STERLING RANCH ROAD CROSSING  
COUNTY OF EL PASO, STATE OF COLORADO  
GRADING AND EROSION CONTROL PLAN  
MAY 2022

STERLING RANCH ROAD CROSSING  
GRADING AND EROSION CONTROL PLAN  
EROSION CONTROL NOTES / DETAILS

**STERLING RANCH ROAD CROSSING  
GRADING AND EROSION CONTROL PLAN**  
GEC PLAN

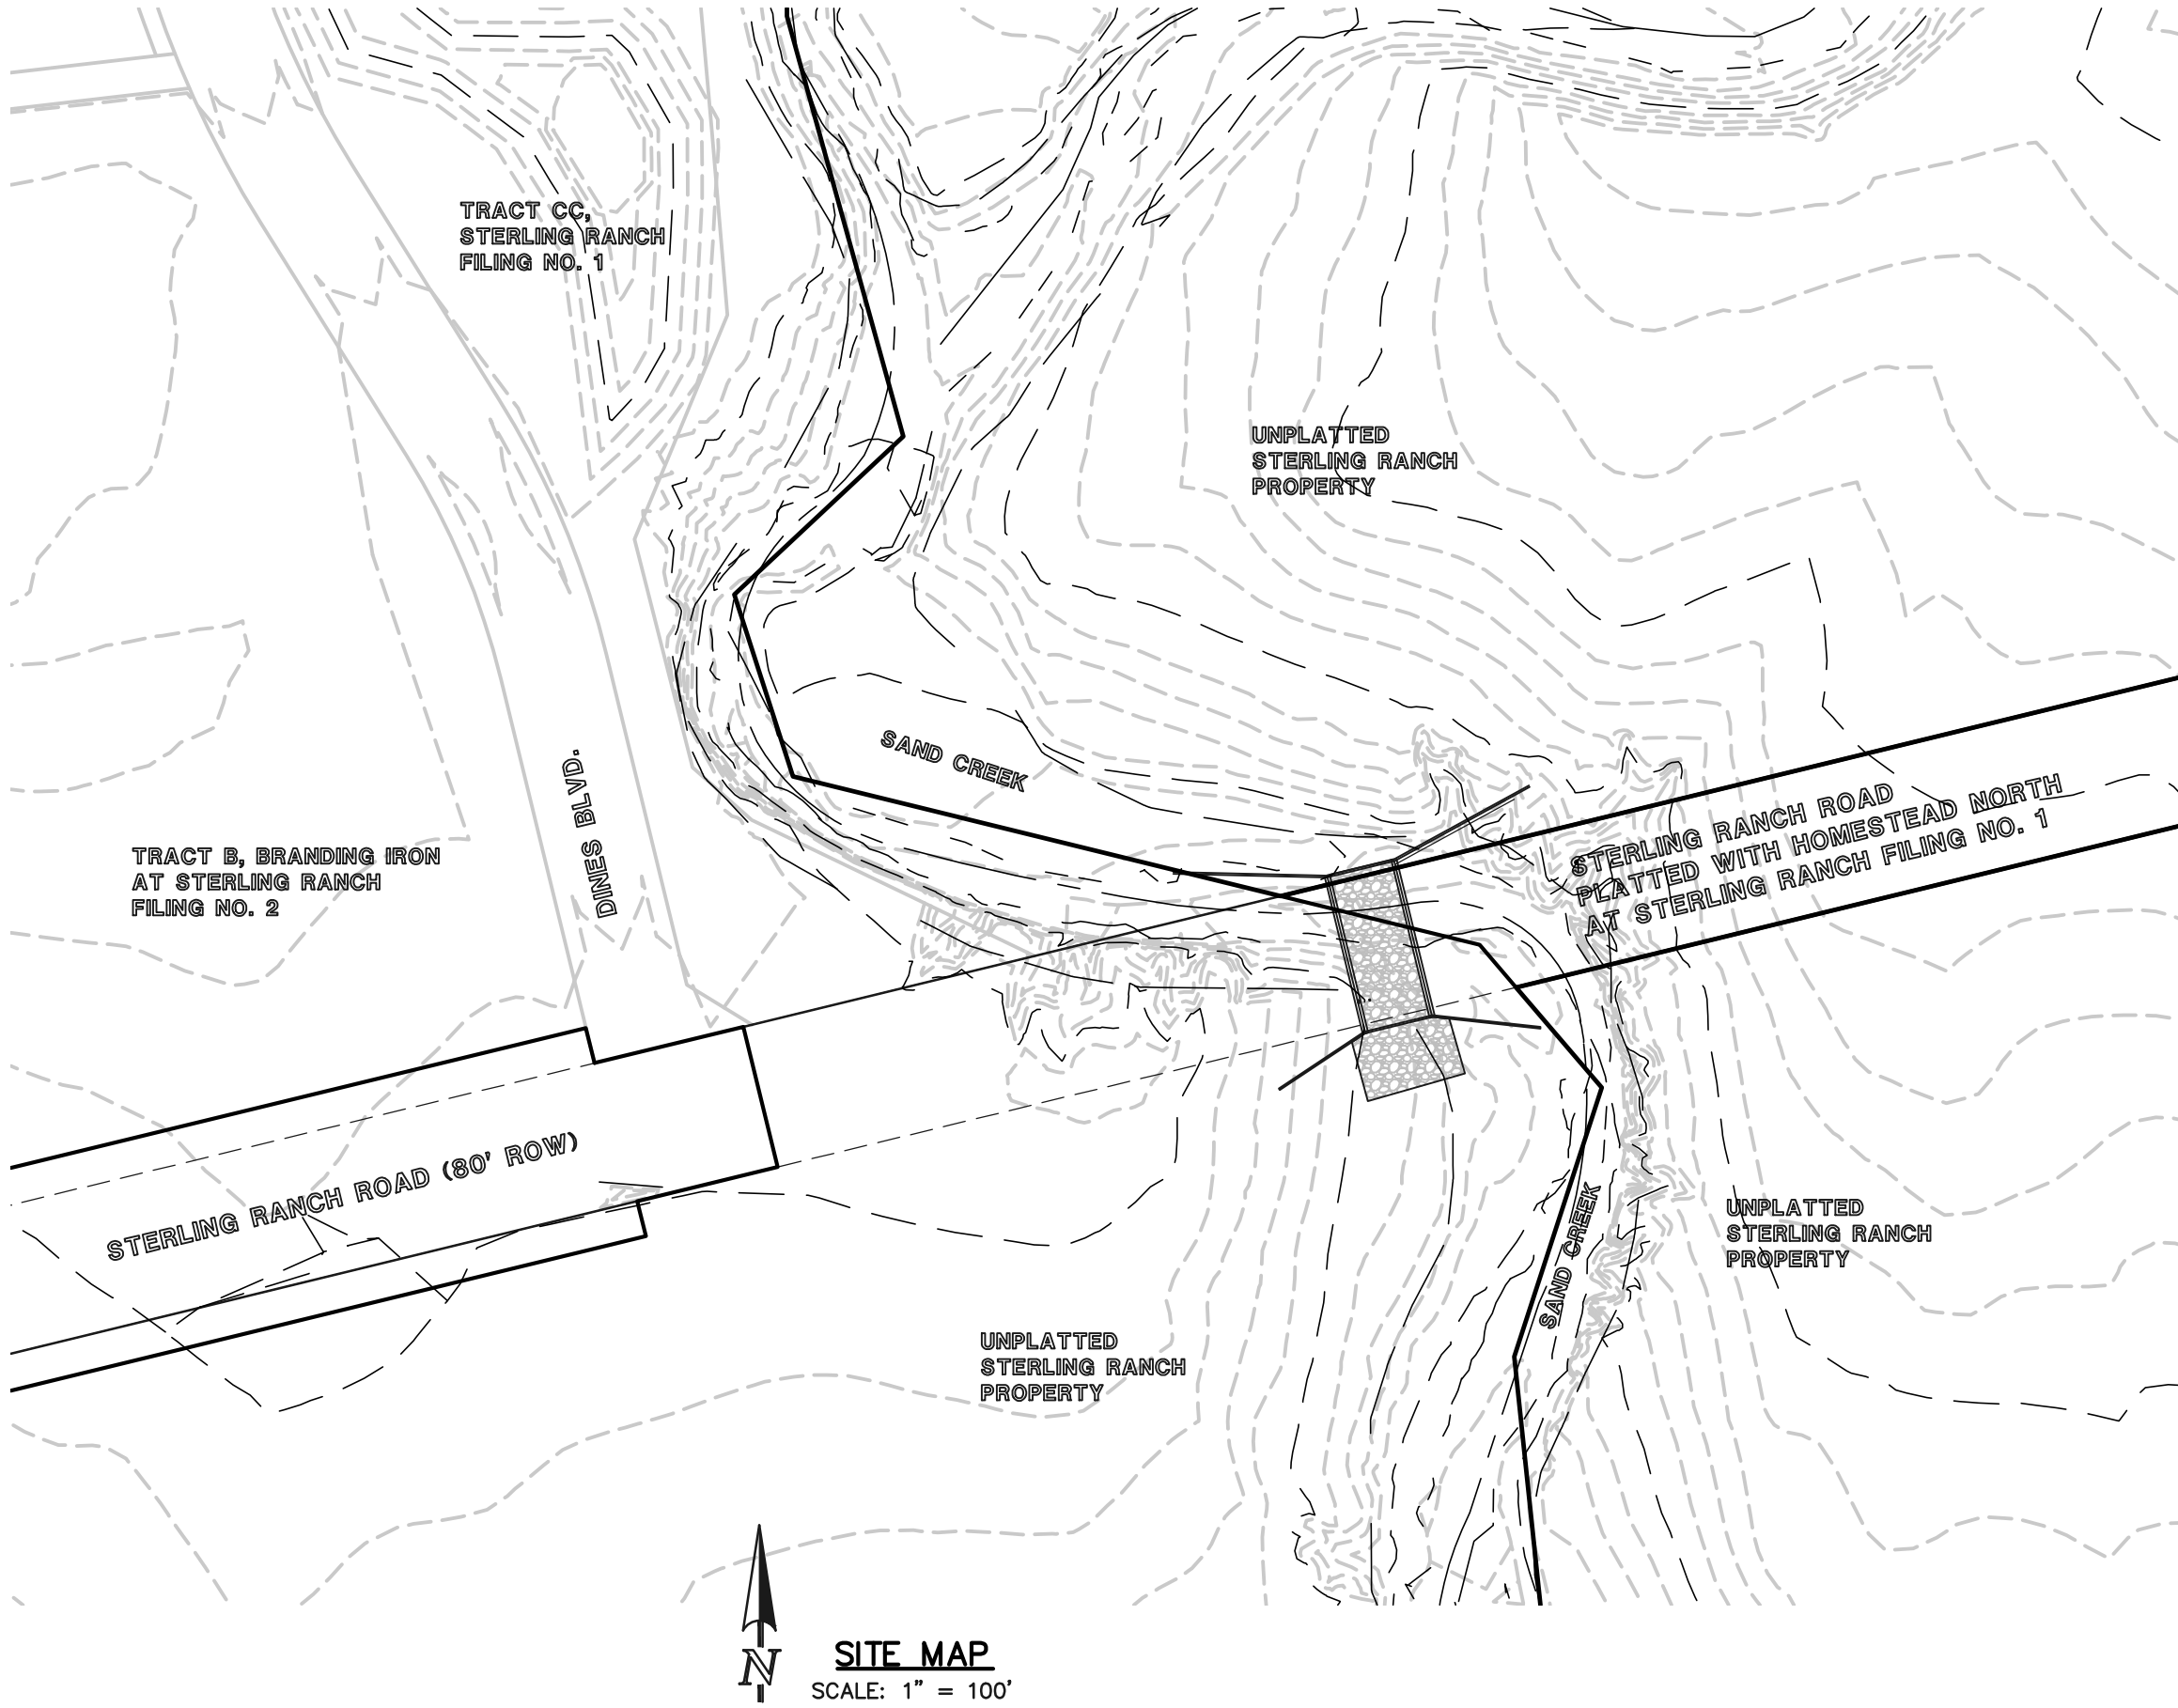
Item Z. Include details for the following BMP's. Examples of acceptable details for each are provided:

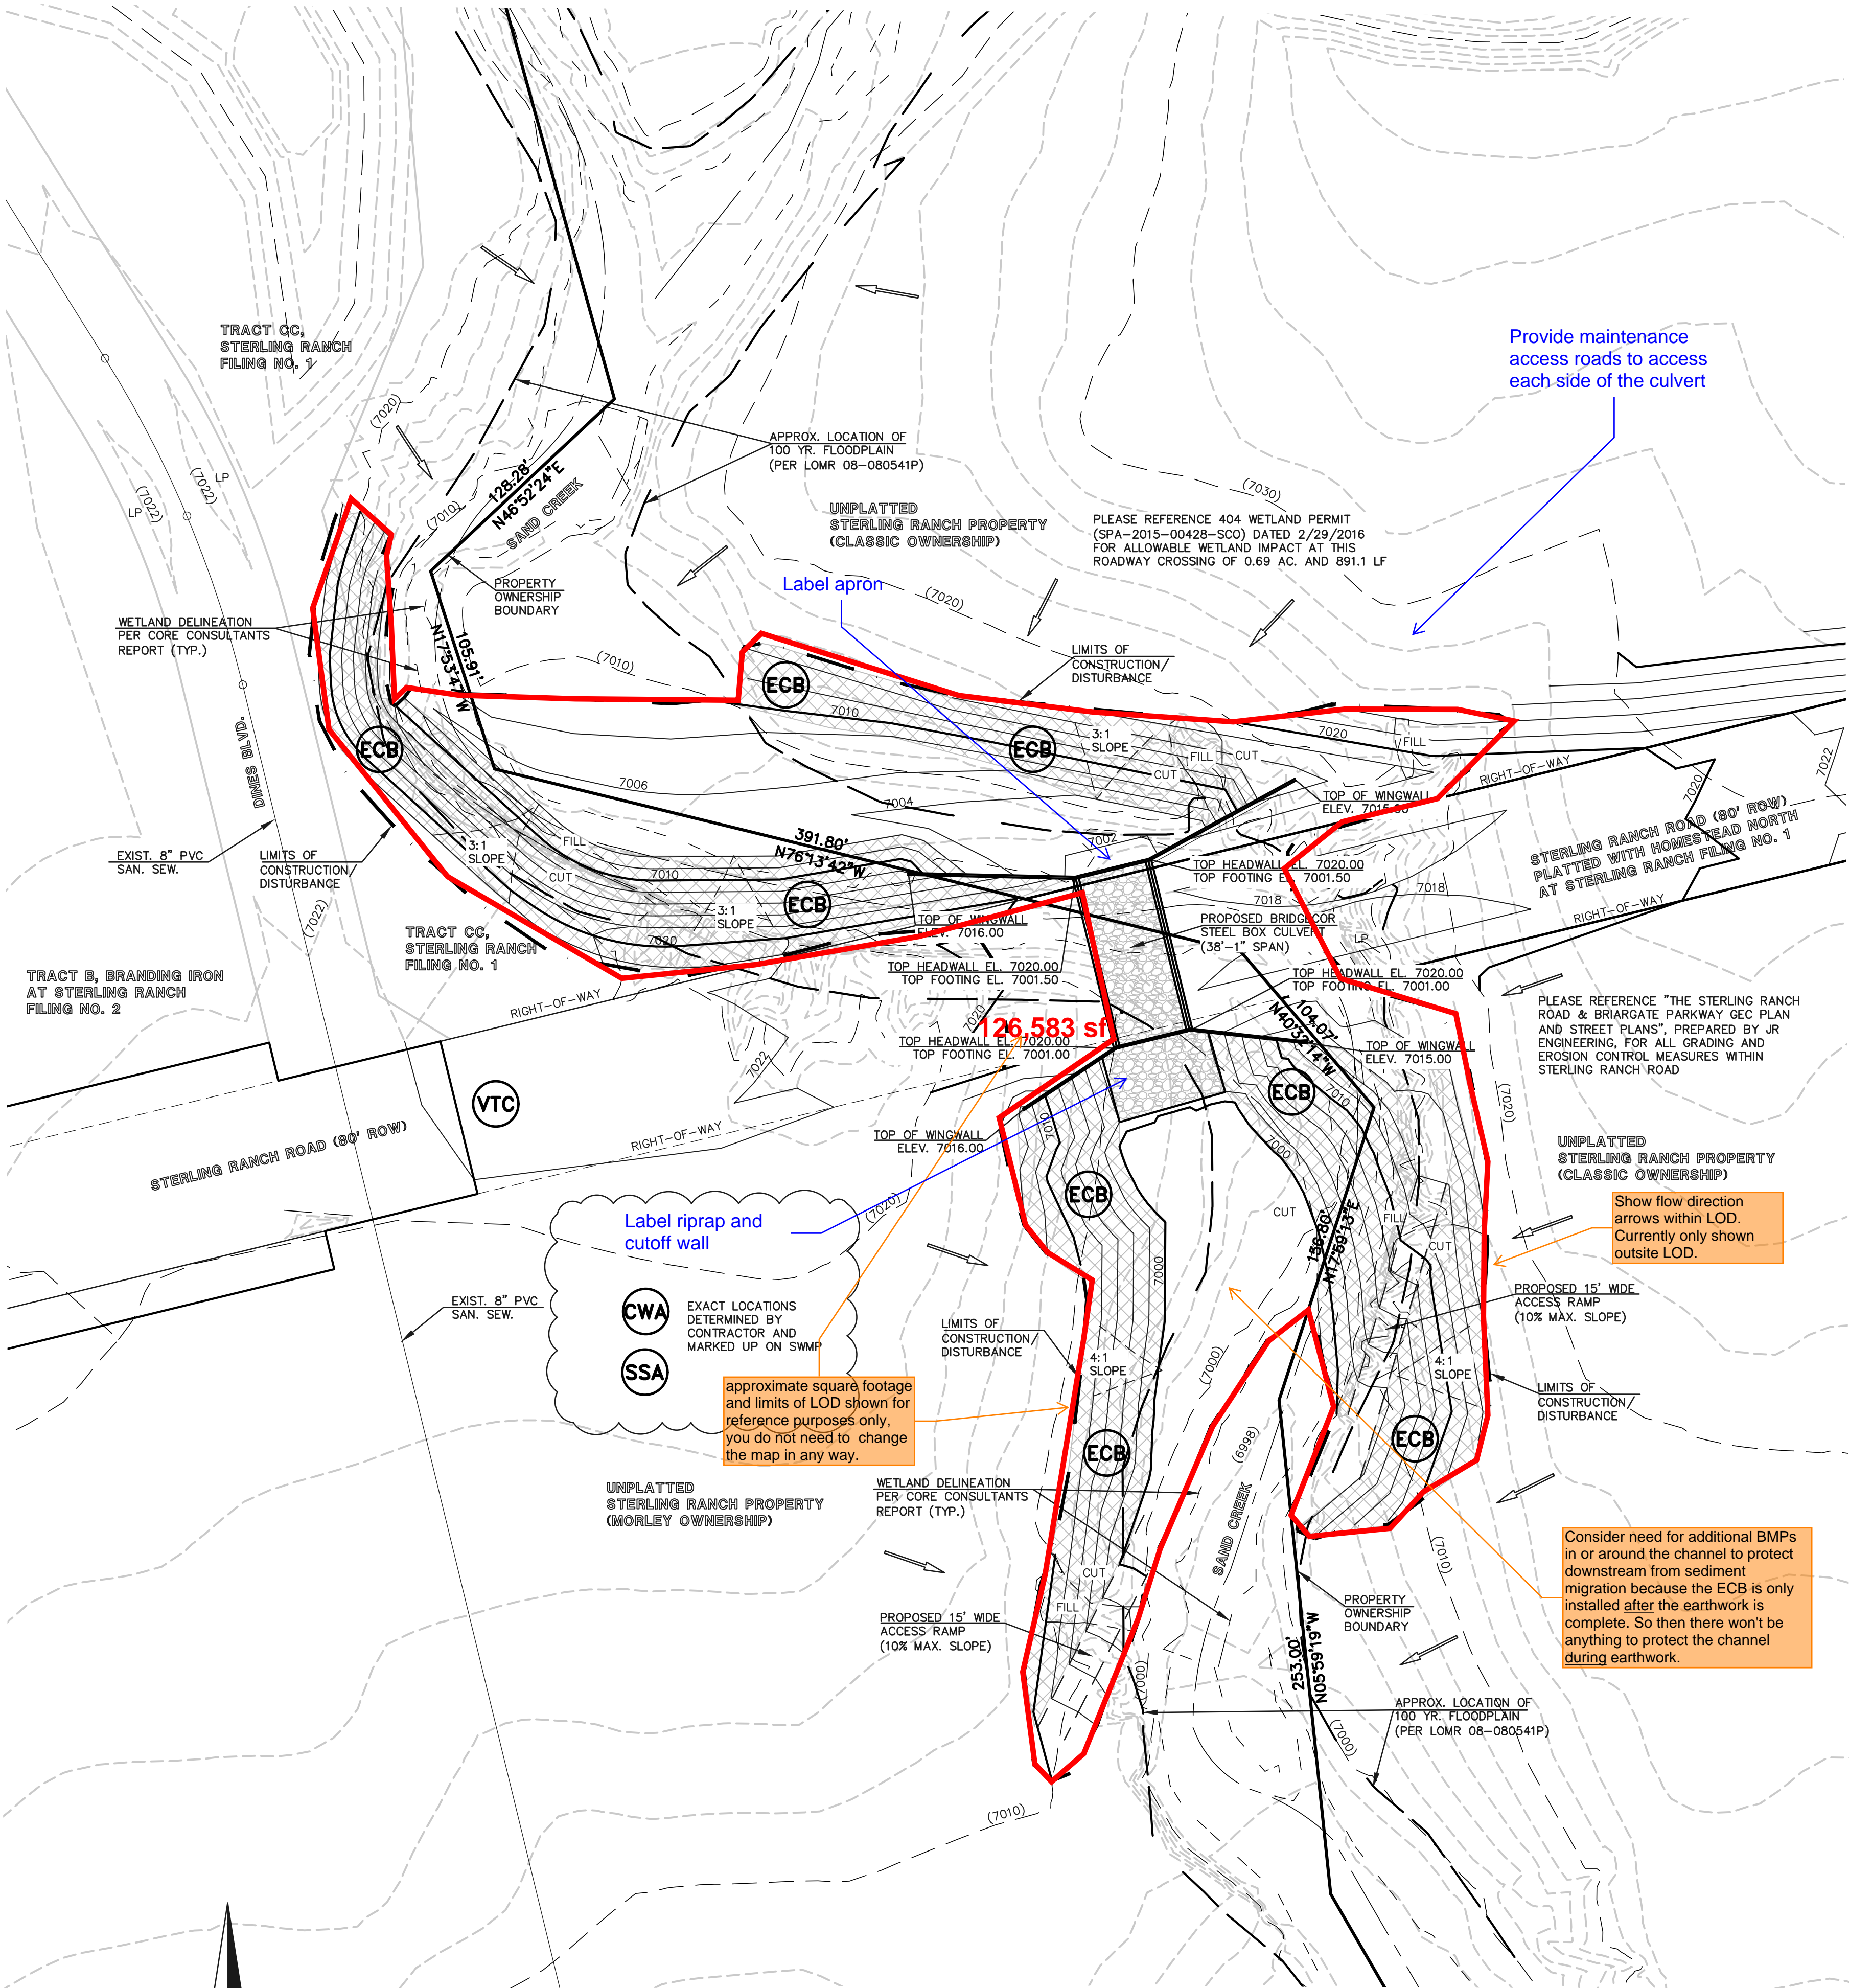
Checklist Item "e" - show property lines, especially the line between Morley and Classic discussed in the LOI.

Provide maintenance  
access roads to access  
each side of the culvert

Label apron

Label riprap and  
cutoff wall

approximate square footage  
and limits of LOD shown for  
reference purposes only,  
you do not need to change  
the map in any way.

Show flow direction  
arrows within LOD.  
Currently only shown  
outside LOD.

Consider need for additional BMPs  
in or around the channel to protect  
downstream from sediment  
migration because the ECB is only  
installed after the earthwork is  
complete. So then there won't be  
anything to protect the channel  
during earthwork.
